Subject: Oconee Nuclear Station  
Docket Nos. 50-269, -270, -287  
Response to Request for Additional Information on  
the Oconee Emergency Power System

REQUEST FOR ADDITIONAL INFORMATION  
OCONEE EMERGENCY ELECTRICAL POWER  
DISTRIBUTION SYSTEM

Graphs of 3LP-17 Current During Test 5

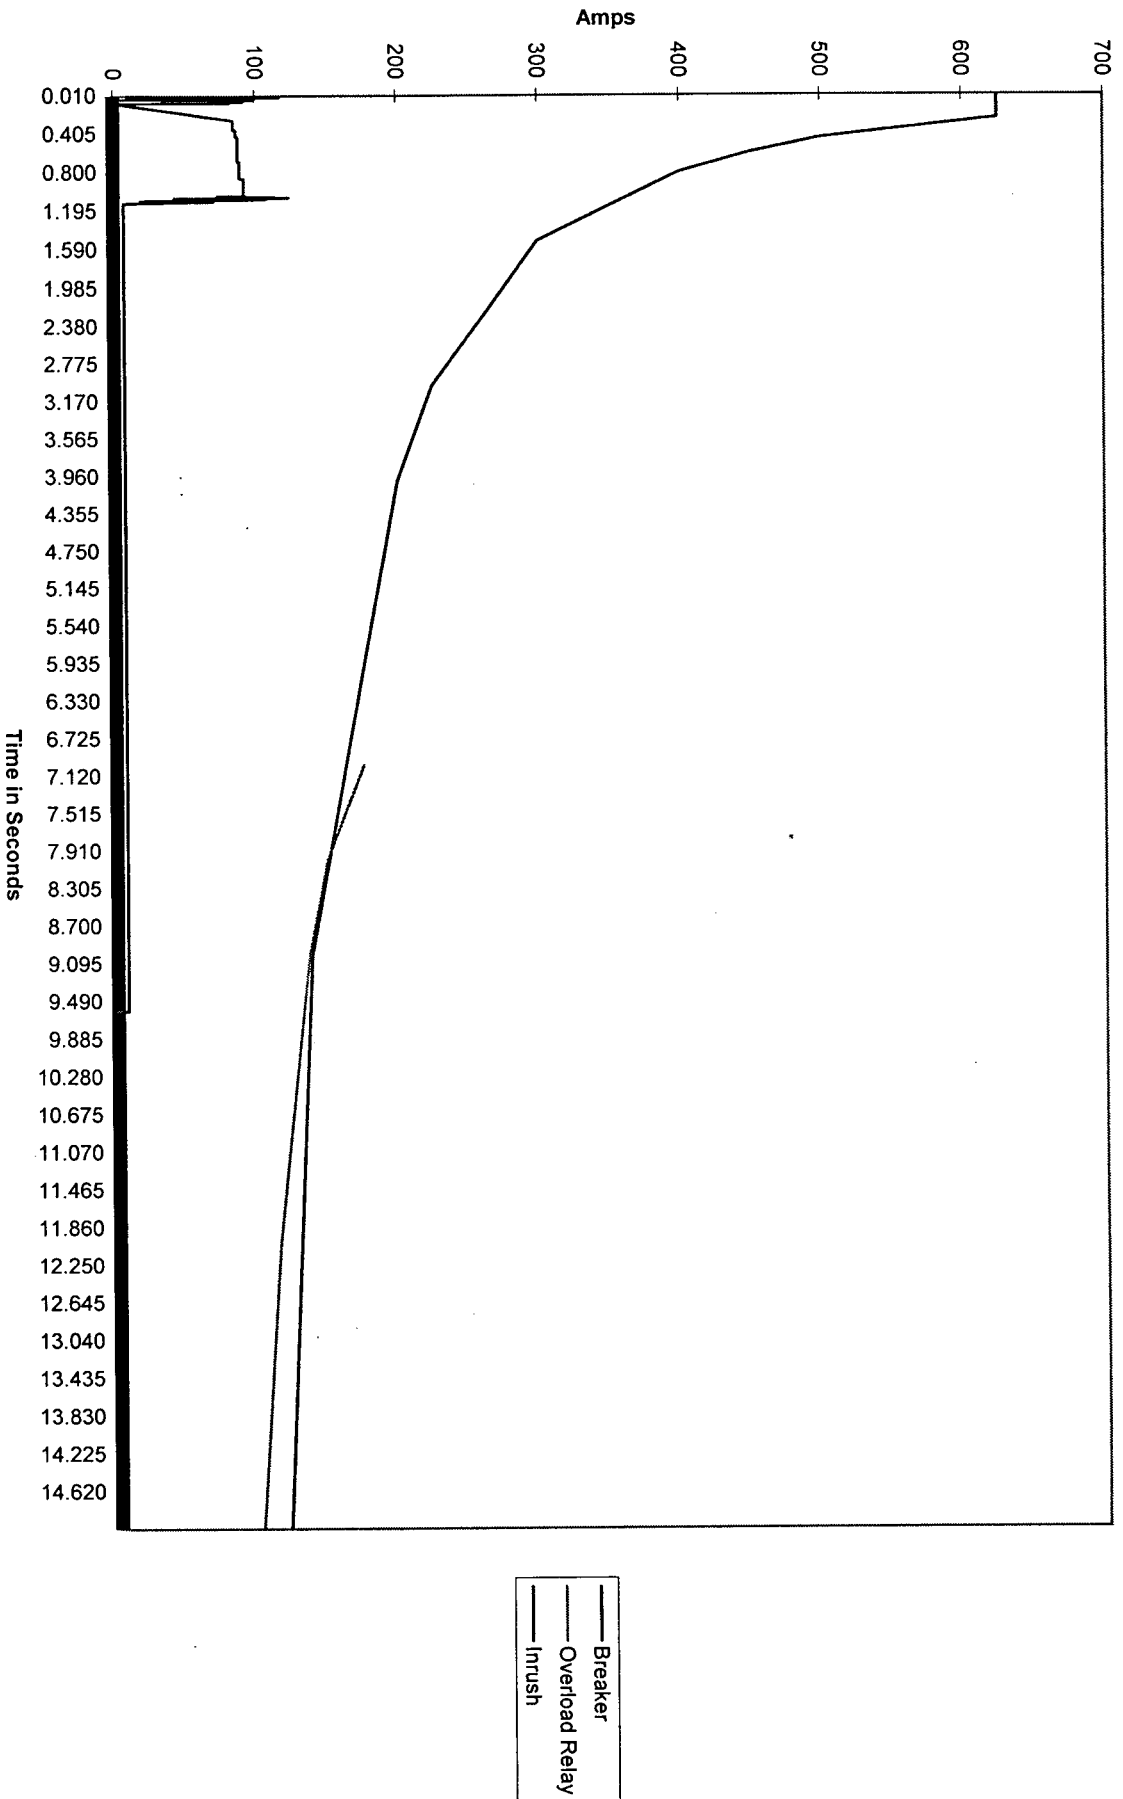
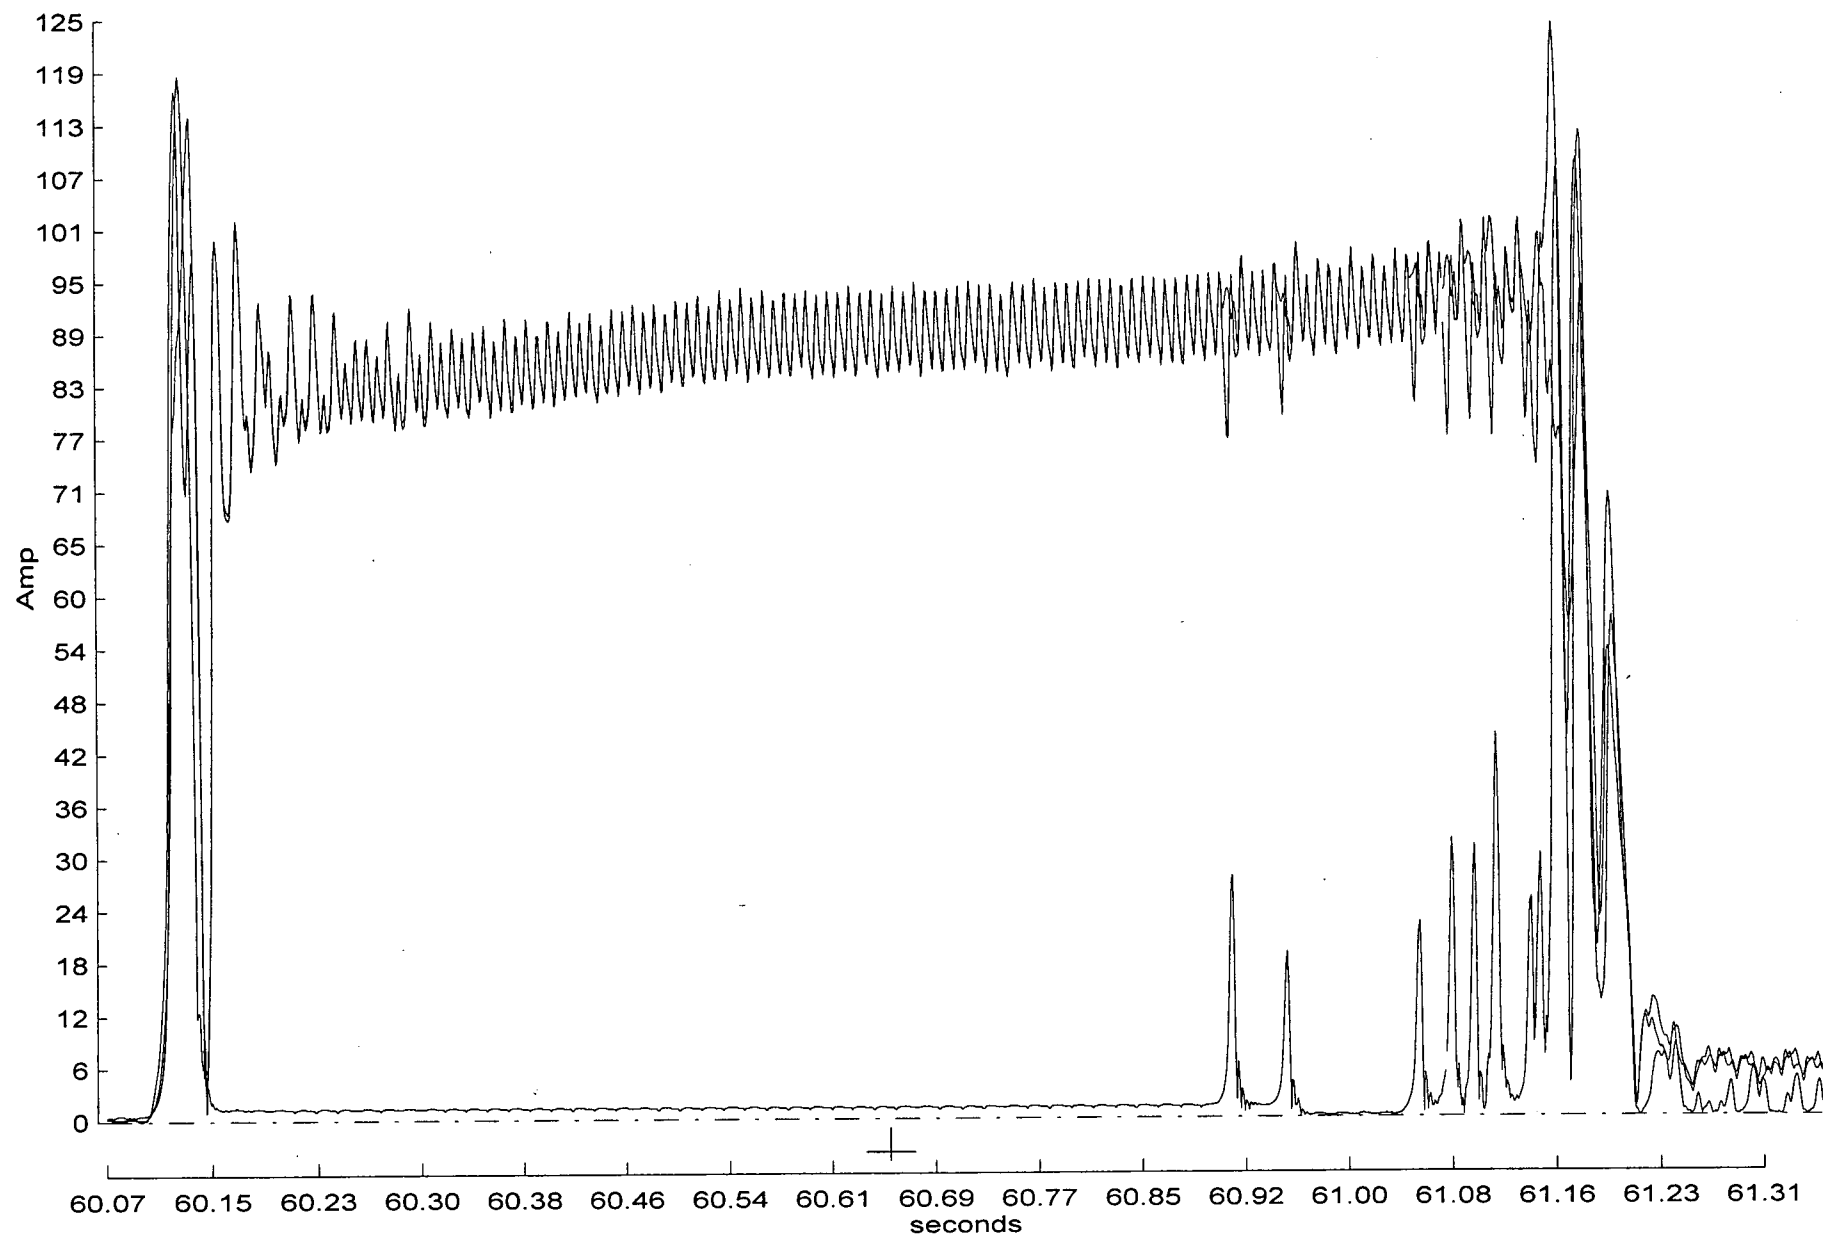
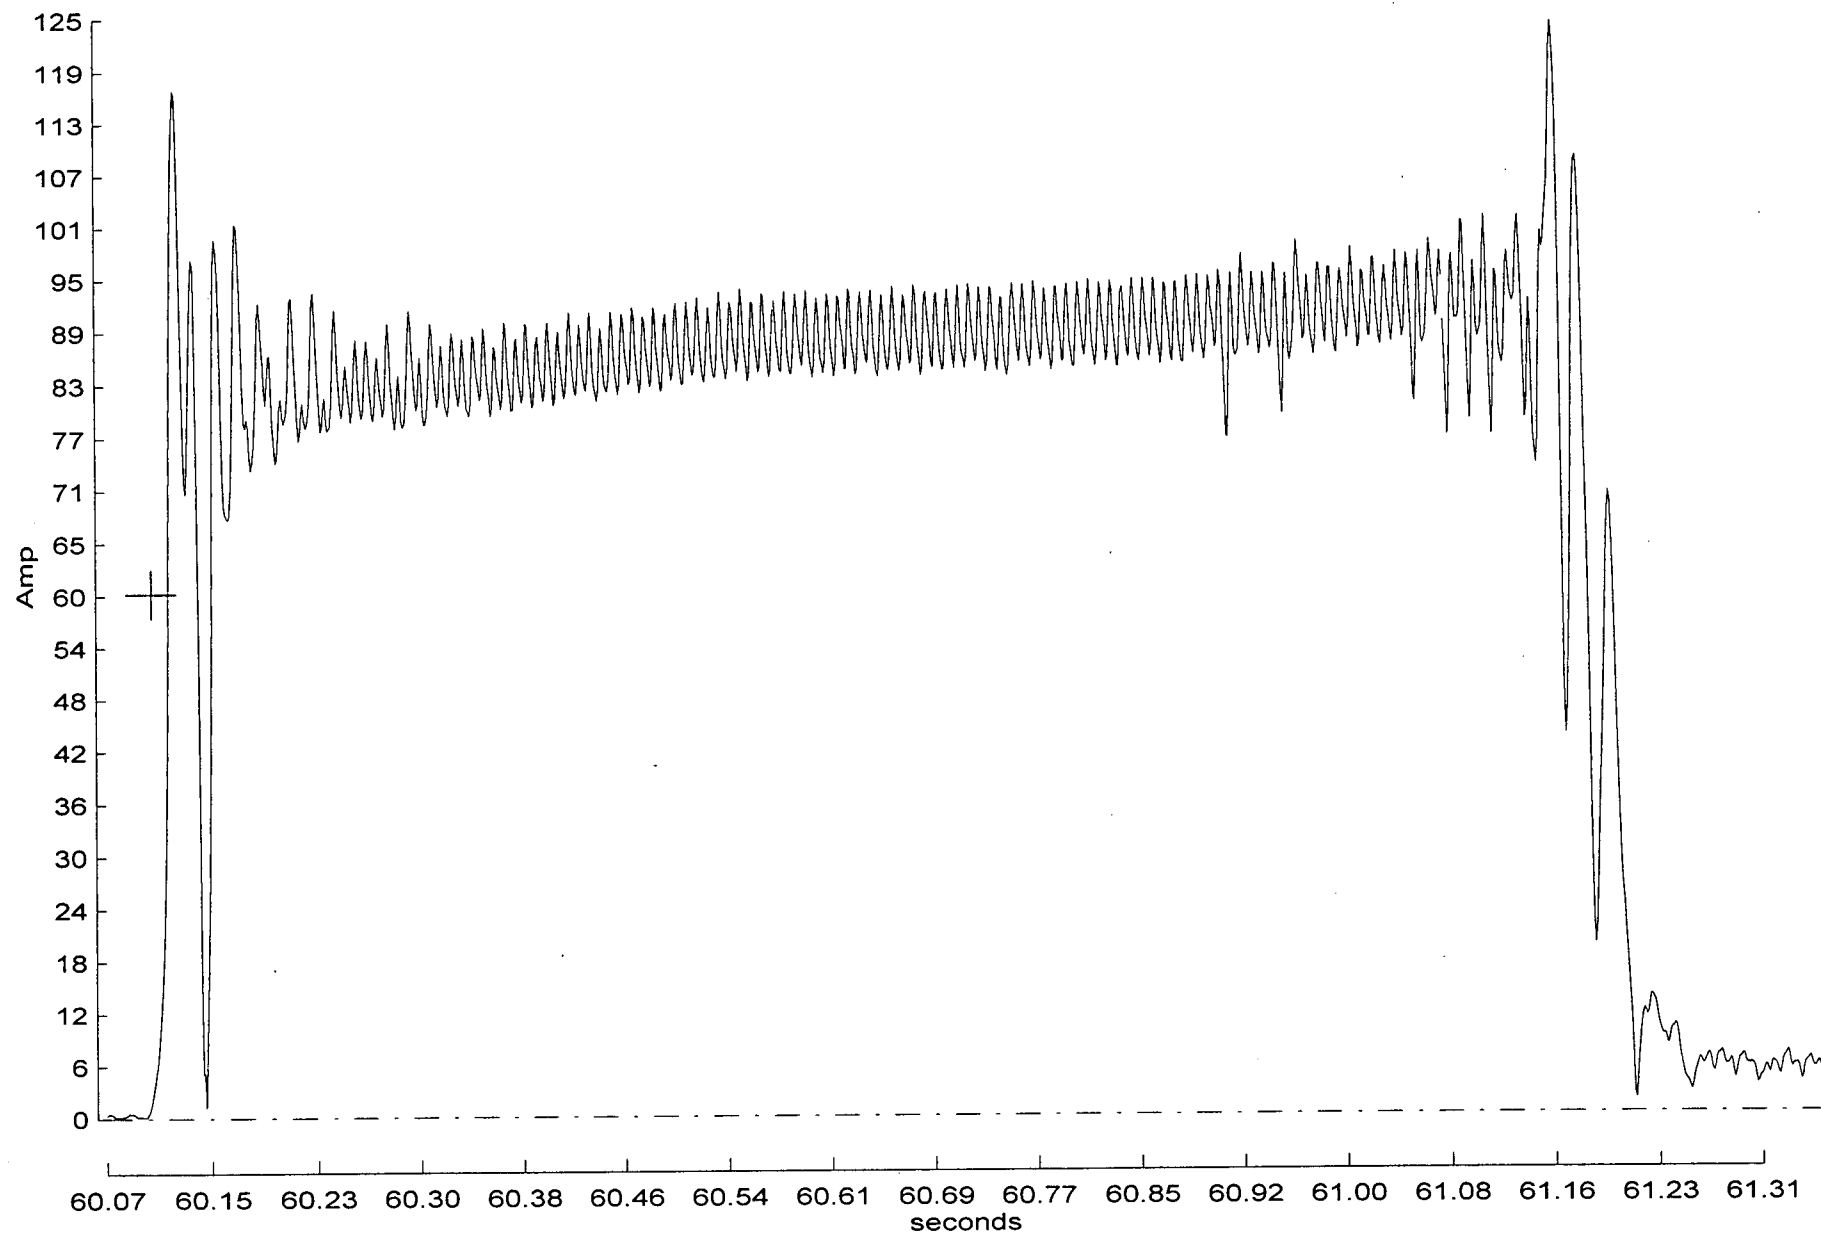
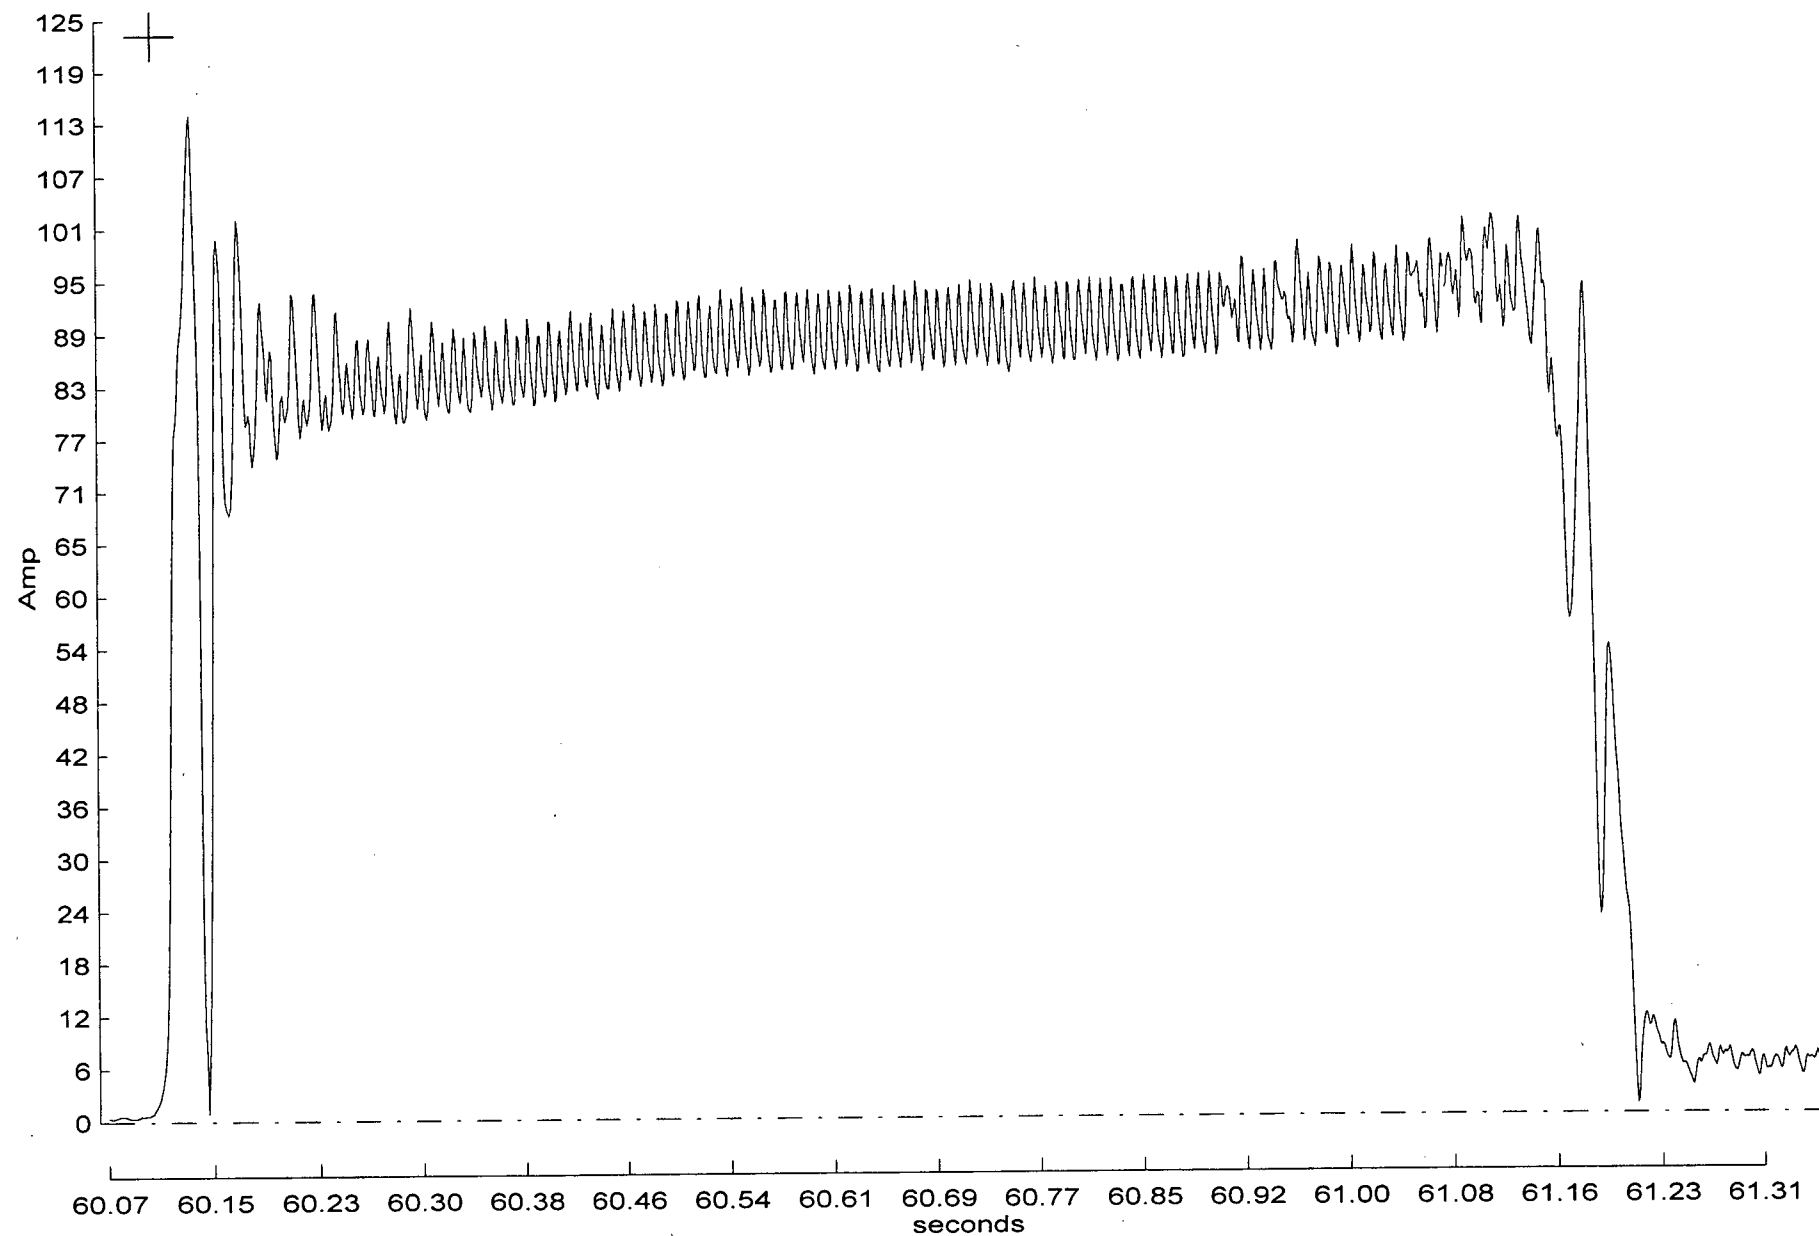
7. Section 5.2.4 of the report states that MOV 3LP-17, which is a gate valve, briefly stalled while starting following contactor pickup during Tests 4, 5, and 6. The stall times were 1.0, 1.0, and 0.4 seconds, respectively, for the three tests. The report indicates that the valve recovered in each case and completed its stroke to its proper ES position; and following inrush, valve stroke was normal and normal hammer-blow and unwedging was observed. We note that in all the LOCA tests where the MOVs are actuated, this particular valve's motor contactor picks up at a voltage value that is quite often one of the largest values seen on the group of valves that are monitored. On that basis, not considering any other variables, it would be expected that this valve would be the least likely to stall.

- d. Please provide plots of the valve motor's thermal capability and overload protection, overlaid on the starting inrush current figures shown for this valve during the tests.

monitored phases was analyzed for inclusion in the report since all valve stroke events could be identified regardless of which phase was analyzed. A more detailed review of the data for all three monitored phases indicates that the primary reason 3LP-17 appeared to stall was that the 'c' phase starter contact chattered while the 'a' and 'b' phase contacts maintained a stable energized state. Therefore, the 'a' and 'b' phases (one of which was included in the report) indicated stall conditions until the 'c' phase contact maintained a stable energized state. Once all three phases were energized, 3LP-17 stroked as expected. In retrospect, 3LP-17 did not actually stall as originally thought. Attachment 6 contains the plots of the current data for 3LP-17 which indicate the chattering of the 'c' phase contact.

Copies of the requested plots are contained in Attachments 2 through 6.
